DEVELOPMENT APPLICATION ASSESSMENT REPORT

Application Number:	DA2023/0045
---------------------	-------------

Responsible Officer:	Gareth David
Land to be developed (Address):	Lot 34 DP 4689, 36 Bardo Road NEWPORT NSW 2106
Proposed Development:	Demolition works and construction of a seniors housing development including basement car parking
Zoning:	R2 Low Density Residential
Development Permissible:	Yes, under State Environmental Planning Policy (Housing) 2021
Existing Use Rights:	No
Consent Authority:	Northern Beaches Council
Delegation Level:	NBLPP
Land and Environment Court Action:	Yes
Owner:	BPG Holdings NSW Pty Ltd
Applicant:	Daniel Michael McNamara

FIGURE 1: Extract of DWG 0628-DA112 01 (longitudinal section) showing 9.5m building height plane and building relationship

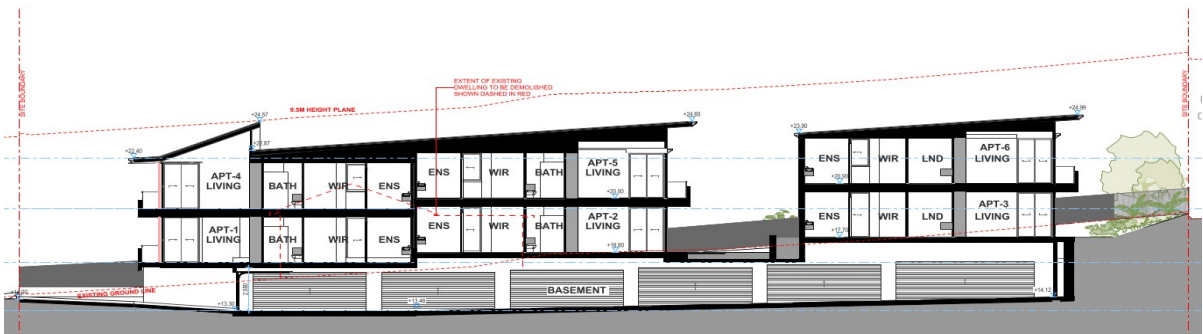
****Note:** Maximum height is measured to the ridge of the projecting skylight at RL24.57 as seen in DWG 0628-DA112 01 by Popov Bass below:

Figure 2 - June 21 9am Eye-of-the-Sun View (Existing on left and proposed on the right).

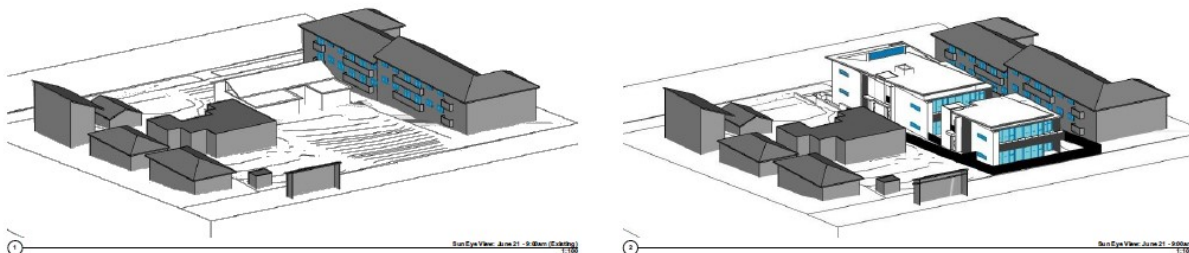
The site most affected by overshadowing with respect to the proposed development is the adjoining neighbour to the west (No.38 Bardo Road, Newport). No.38 Bardo Road consists of three storey residential flat building (including a basement/lower ground floor garage) comprising of 16 units. Of these 16 units, 12 have balconies (and principle private open space) located facing east towards towards the subject site (as demonstrated in figure 1 below). The submitted shadow diagrams demonstrate that all of these balconies currently receive direct solar access at 9am and 10am and a portion of these units receive sunlight at 11am. These balconies do not receive sunlight after 11am.

As demonstrated in Figure 2 below, the proposal would result in four of the ground floor unit balconies (and principle private open space) receiving no sunlight at 9am. This would result in the private open space of four adjoining dwellings receiving less than three hours of sunlight between 9am and 3pm on June 21, which does not comply with the requirements of this control.
